Addendum No. 1

Project: Village on the Preserve – Phase 2
For: Lanoha Development

Date: 1 February 2012
 From: Studio 951, Ltd.
 To: All plan holders.

A2.01-1

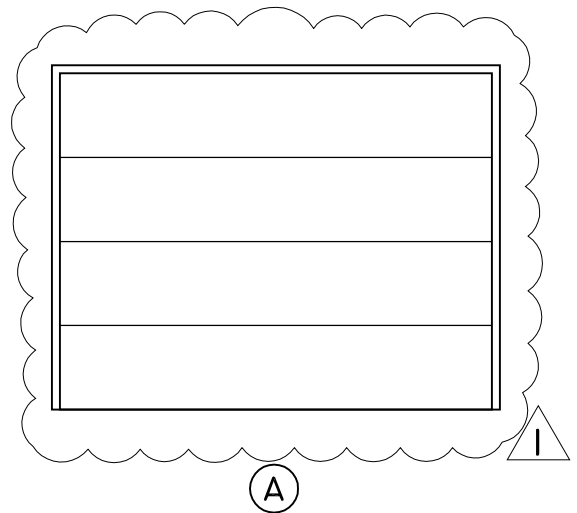
See A2.01-1, A2.01-2 showing a revised door schedule and a modification to the finish schedule.

A2.03-1

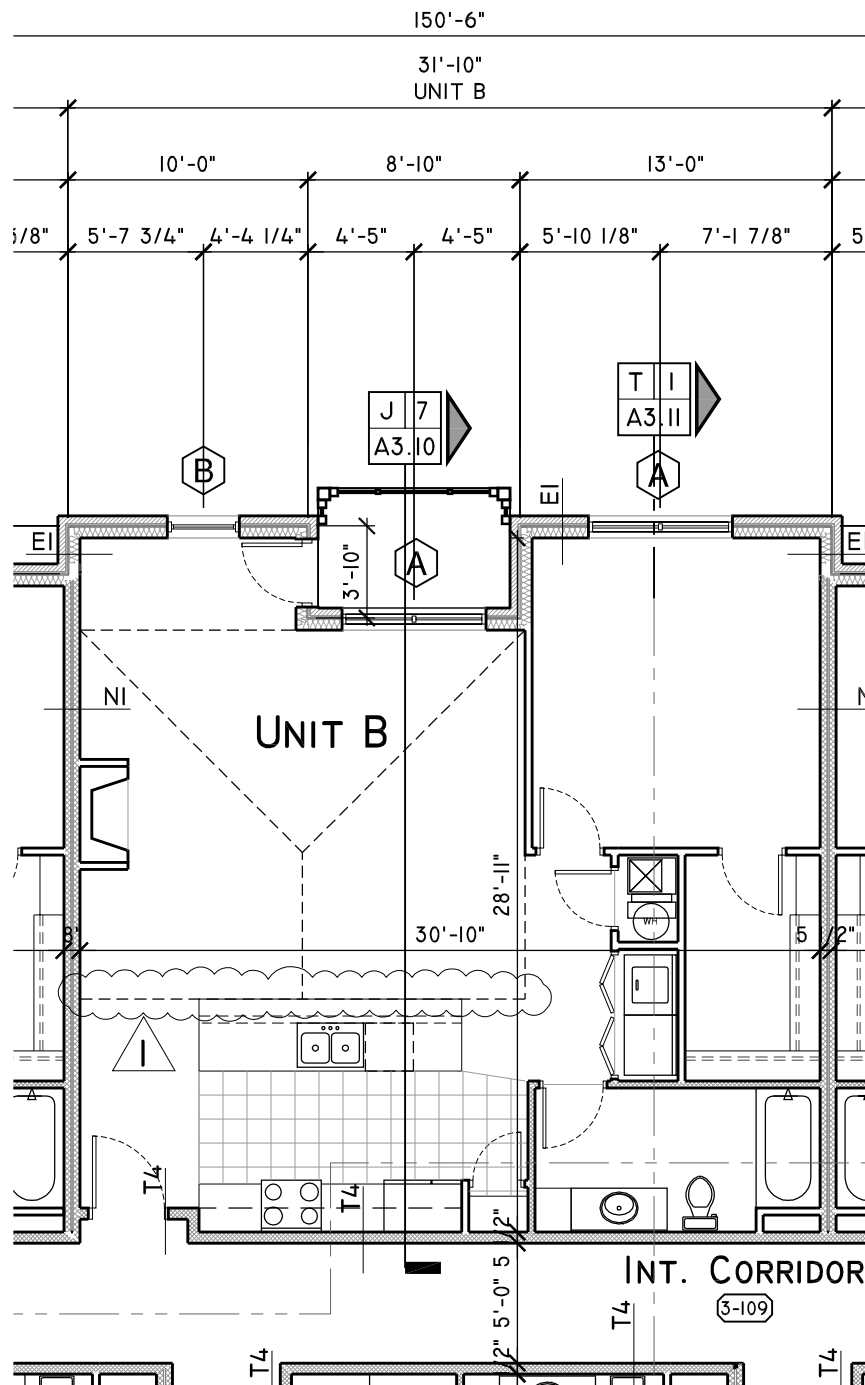
See A2.03-1 with a revision to the ceiling vault depicted in Unit B.

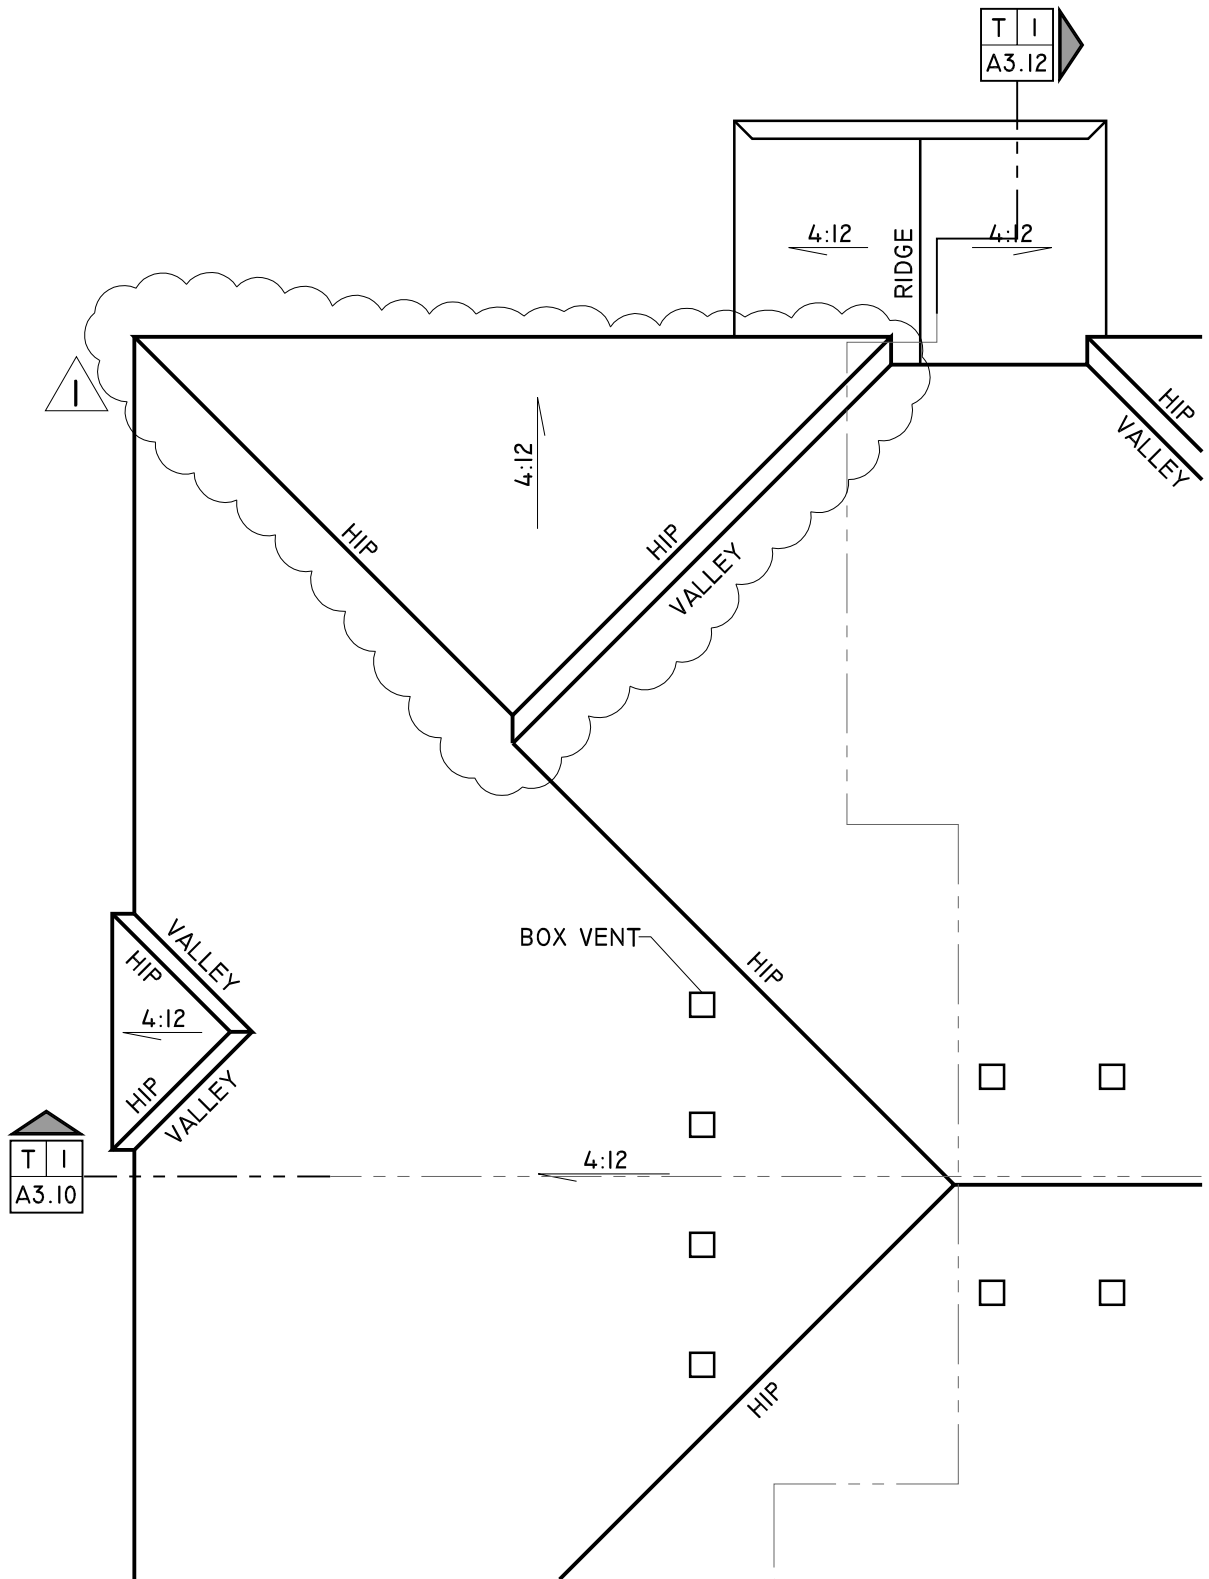
See A2.04-1, A2.04-2 showing revisions to the roof plan.

A3.01-1
 Addedda 01
 Drawing released > 1 Feb 2012

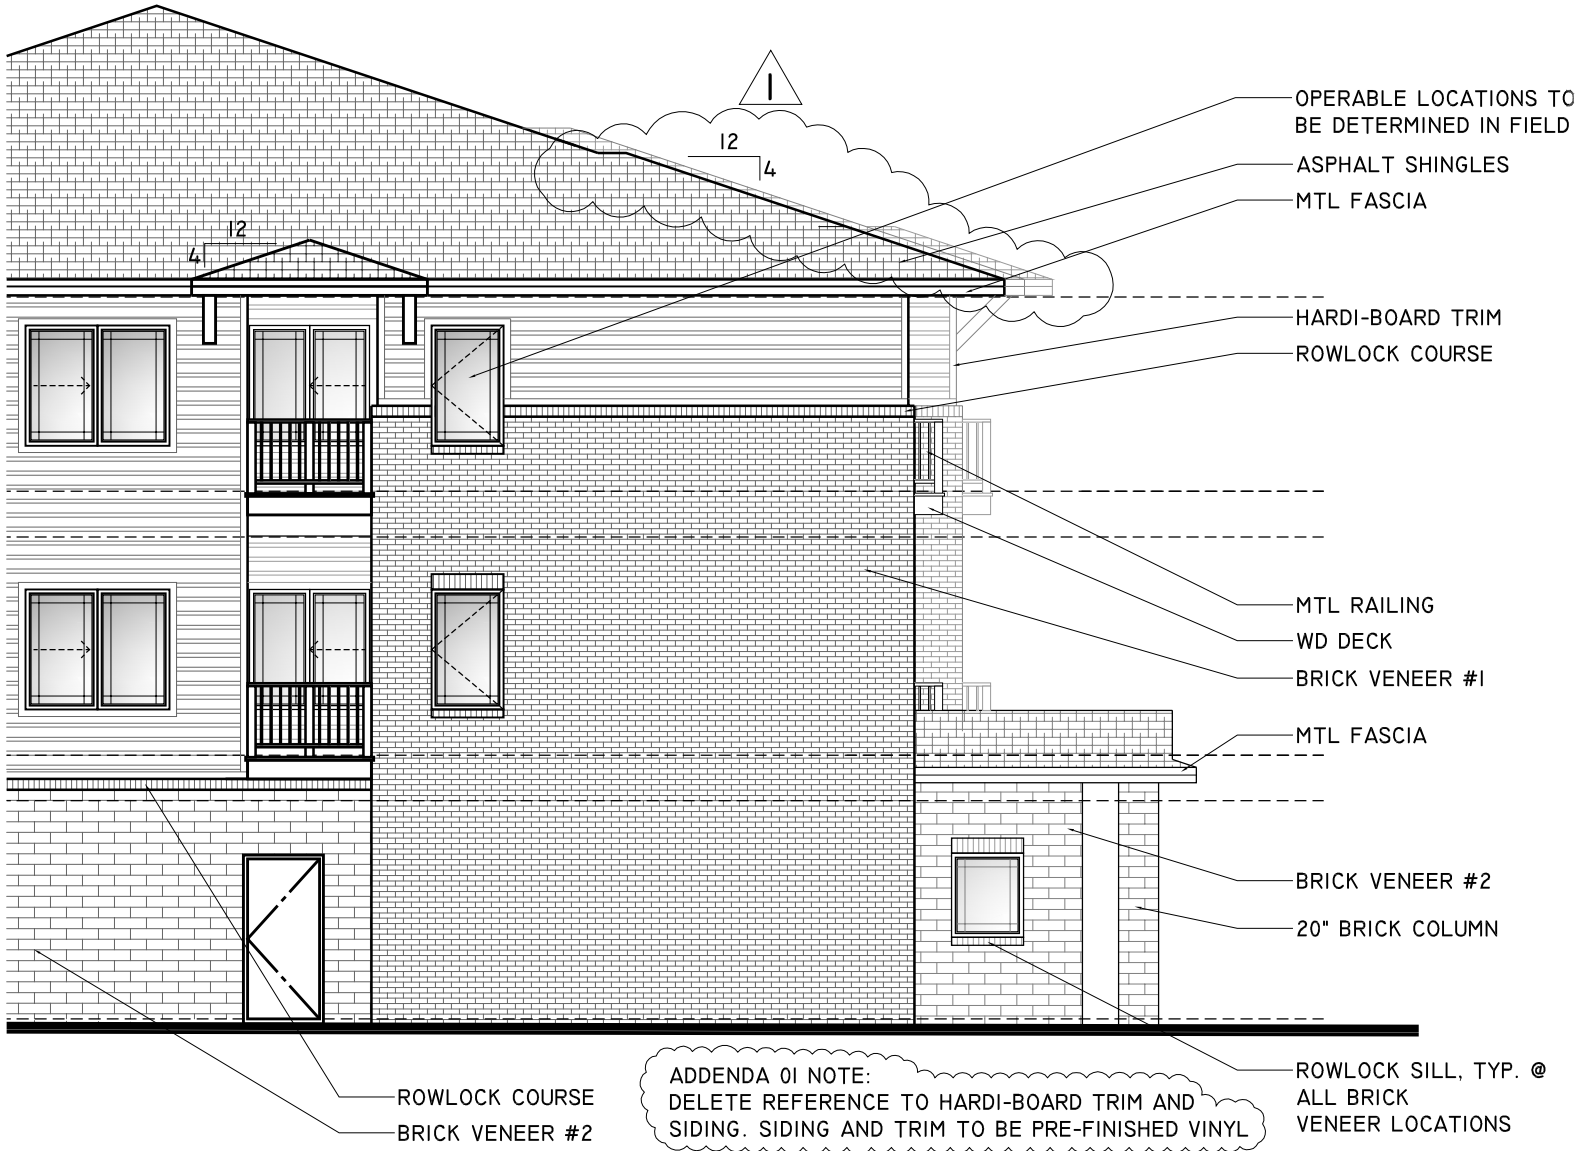
See A3.01-1, A3.01-2 showing revised side elevations to show coordination with roof plan. See a note regarding siding and trim material which applies to all building exterior elevations.

ADDENDA 01 NOTE:
 DELETE REFERENCE TO HARDI-BOARD TRIM AND
 SIDING. SIDING AND TRIM TO BE PRE-FINISHED VINYL

A3.01-2

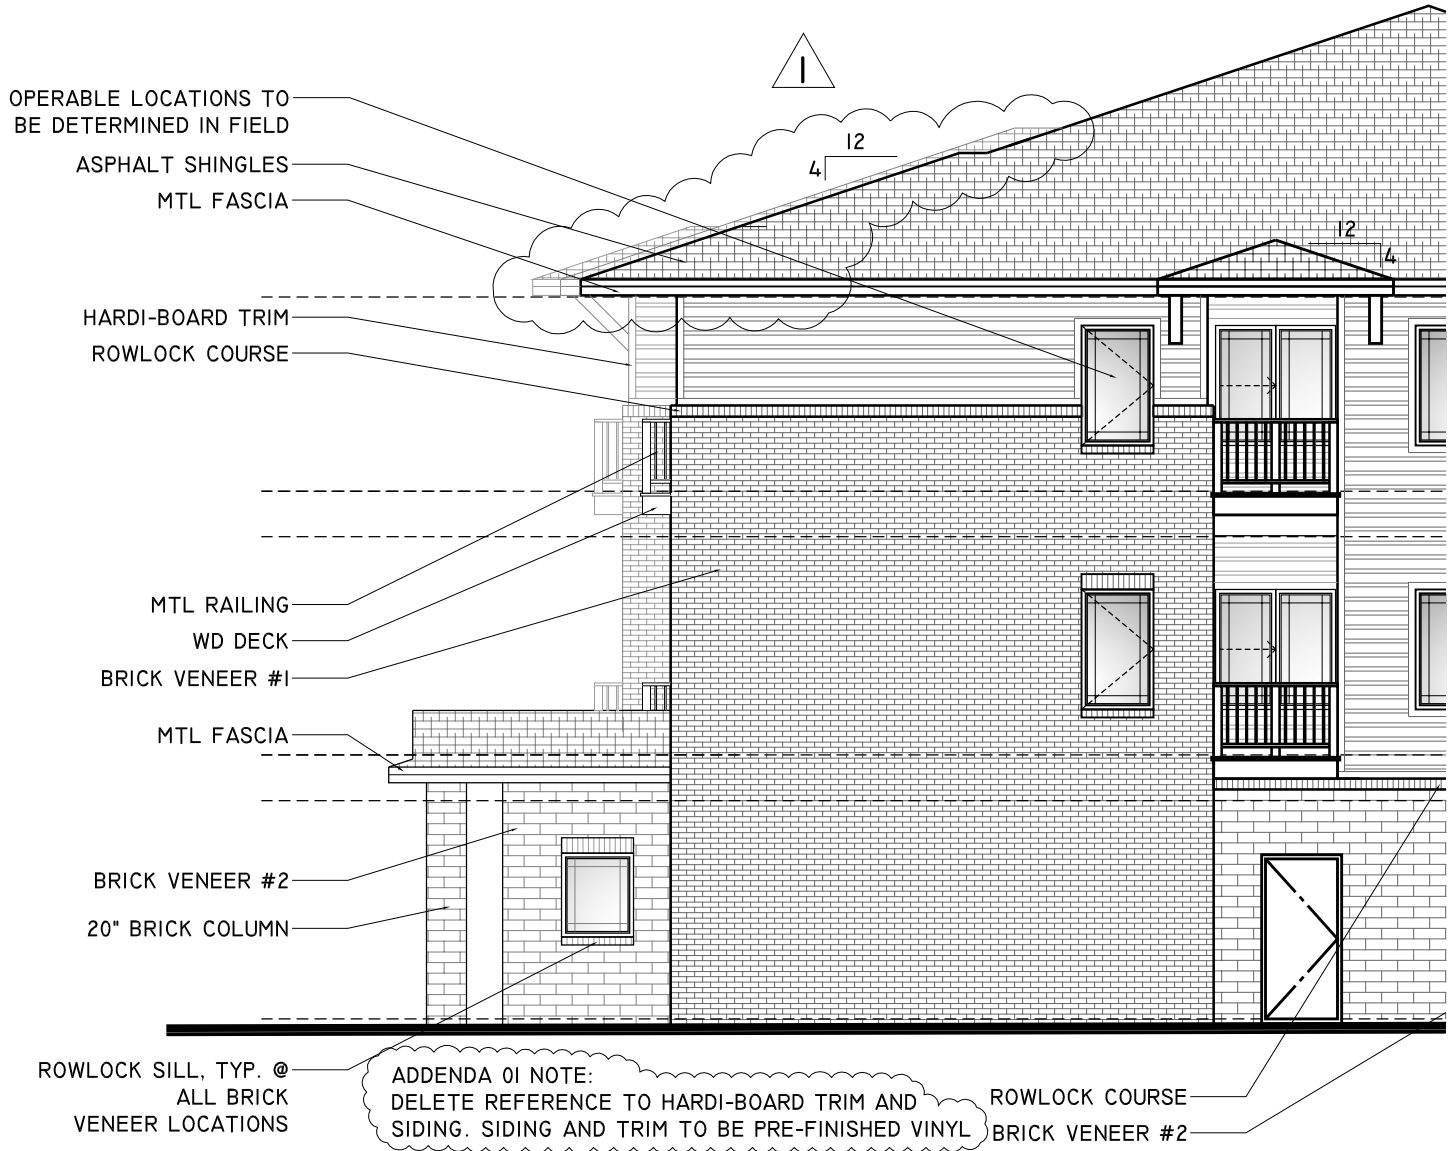
ADDENDA 01 NOTE:
 DELETE REFERENCE TO HARDI-BOARD TRIM AND
 SIDING. SIDING AND TRIM TO BE PRE-FINISHED VINYL

A3.12-2
Addedda 01
Drawing released> 1 Feb 2012

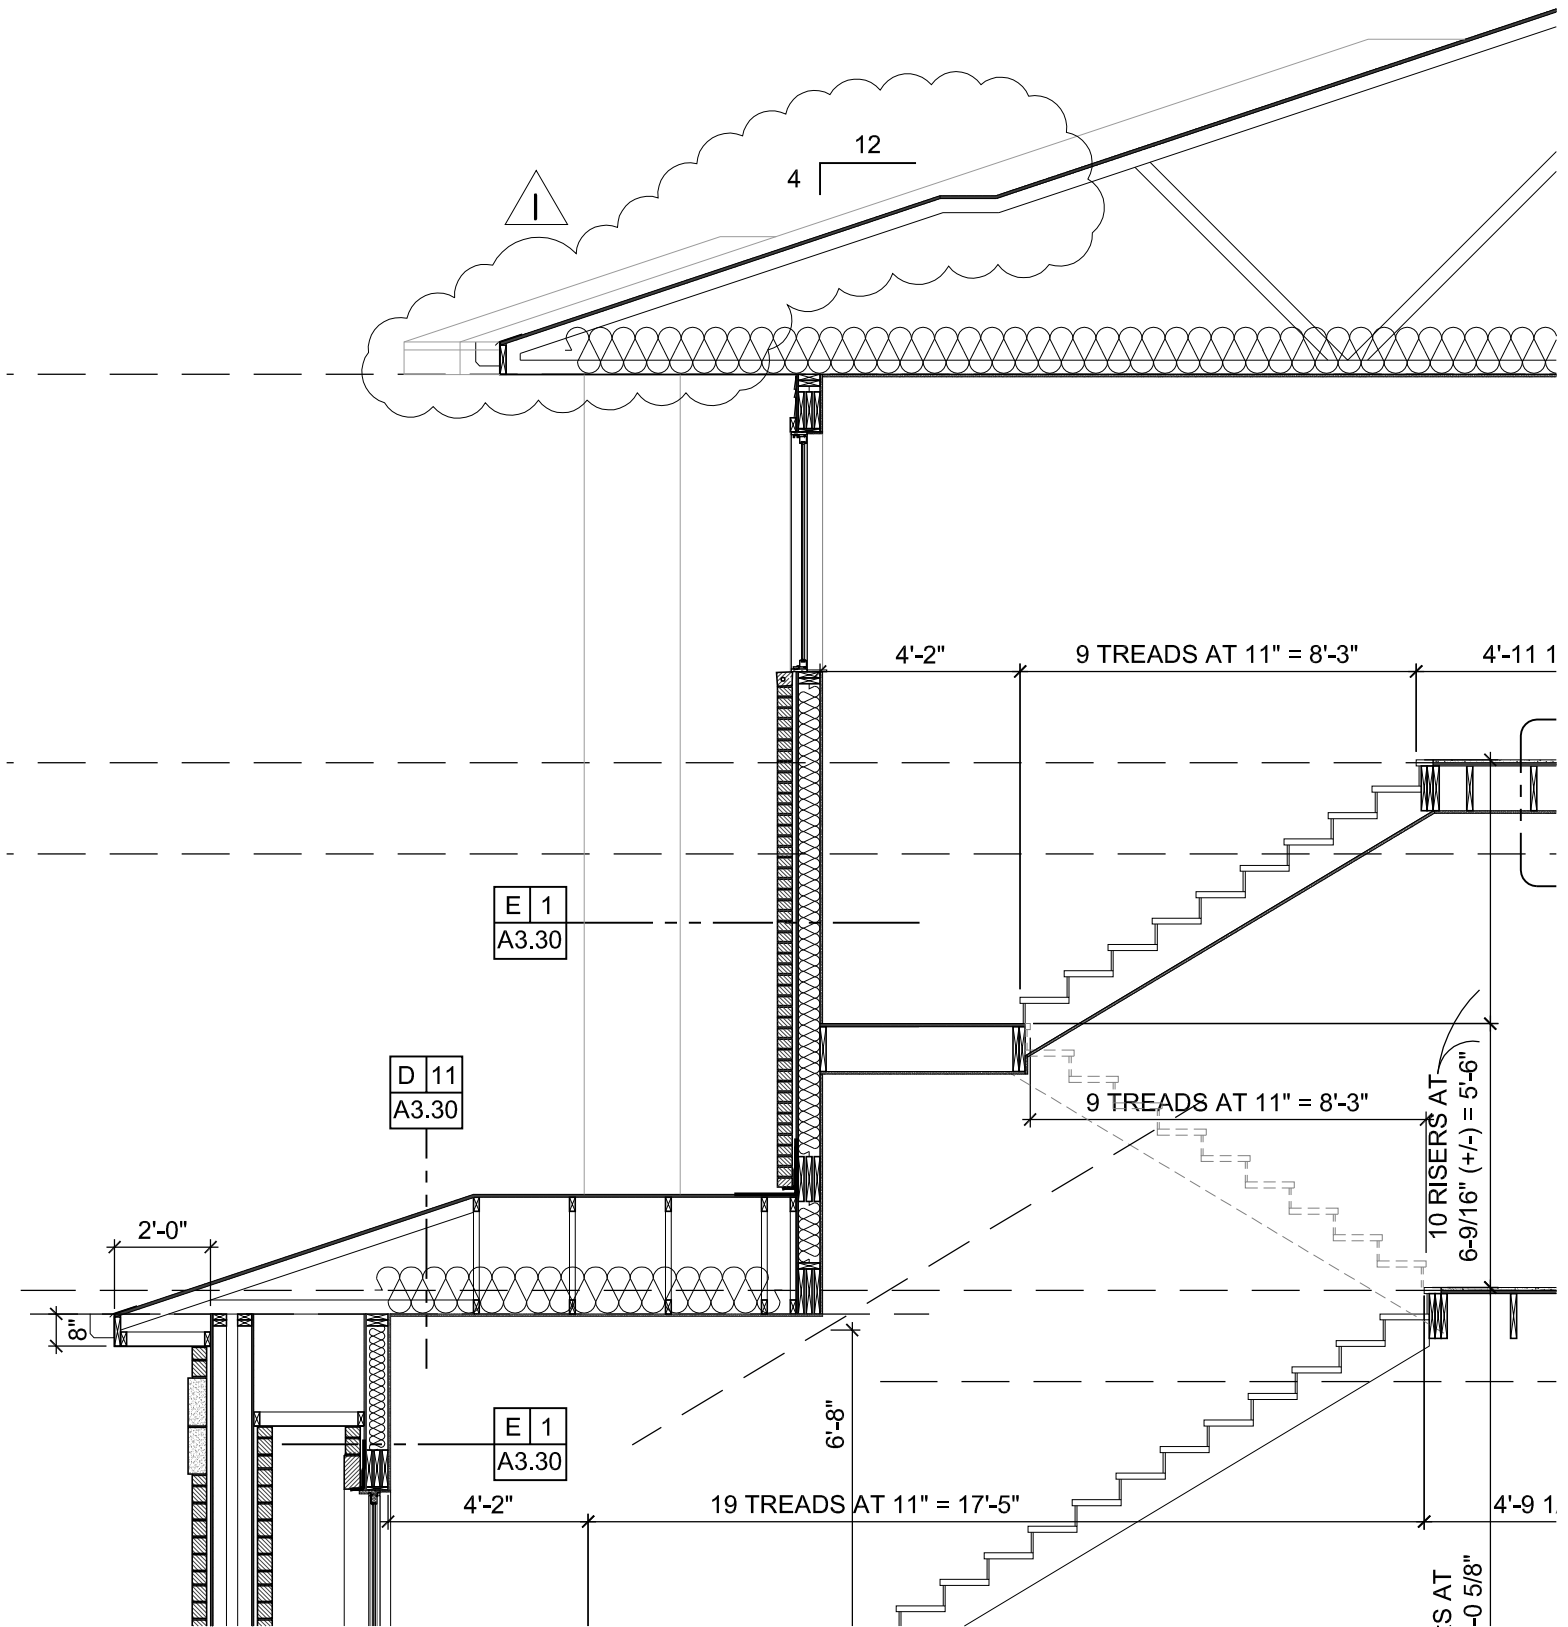
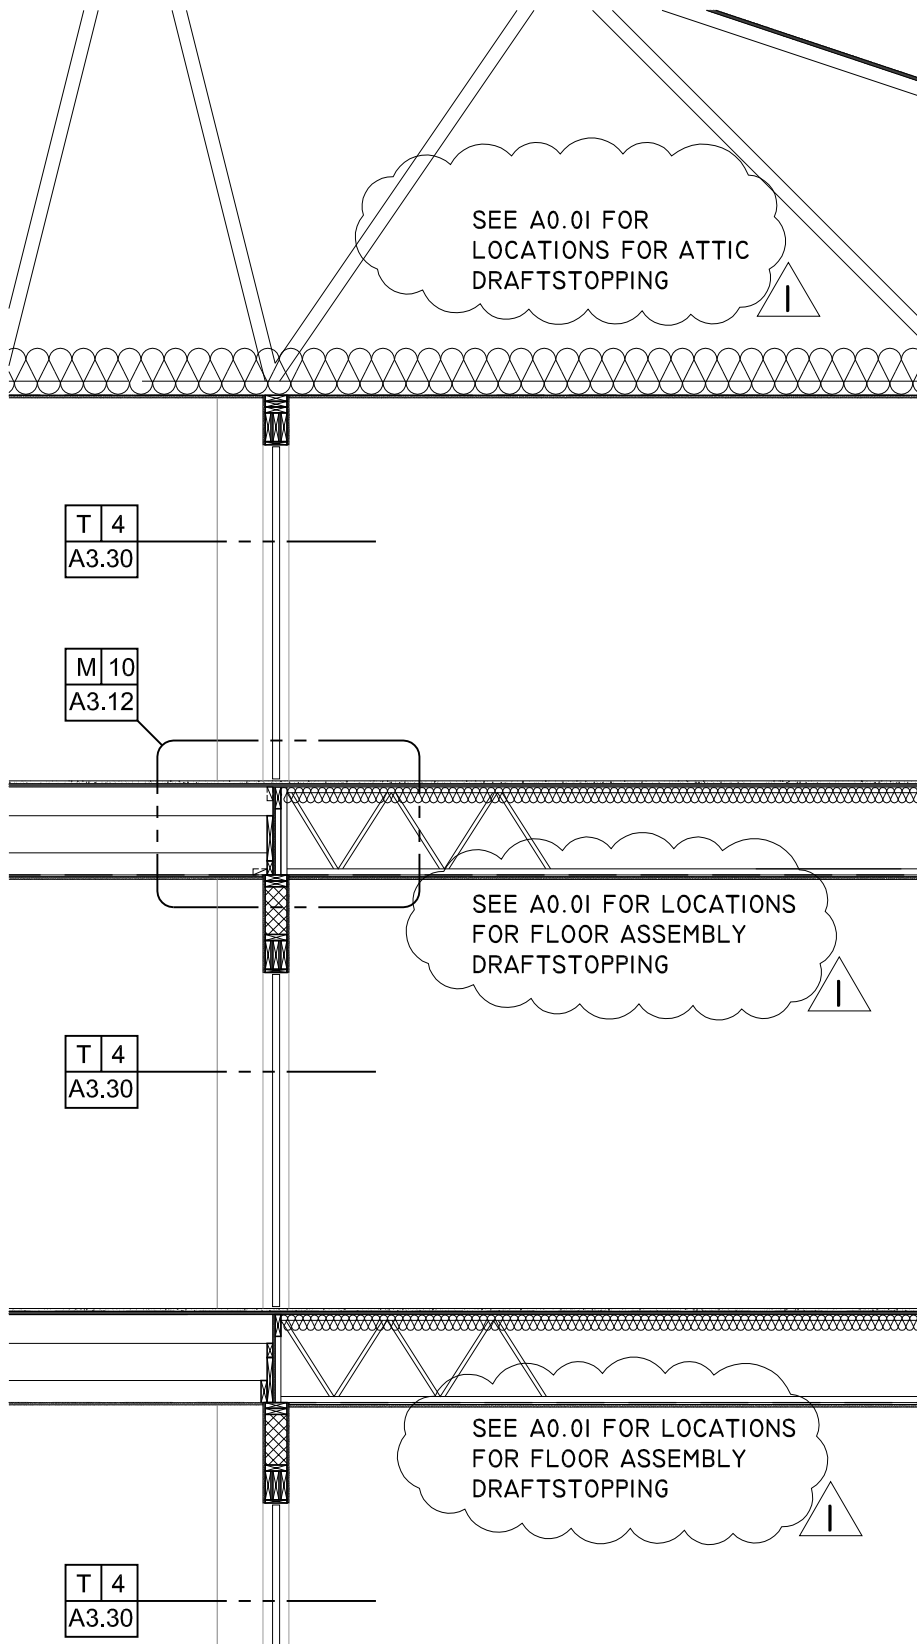
See A3.12-1, A3.12-2 showing a revised building section to show coordination with roof plan. See a note regarding attic and floor assembly draftstopping.
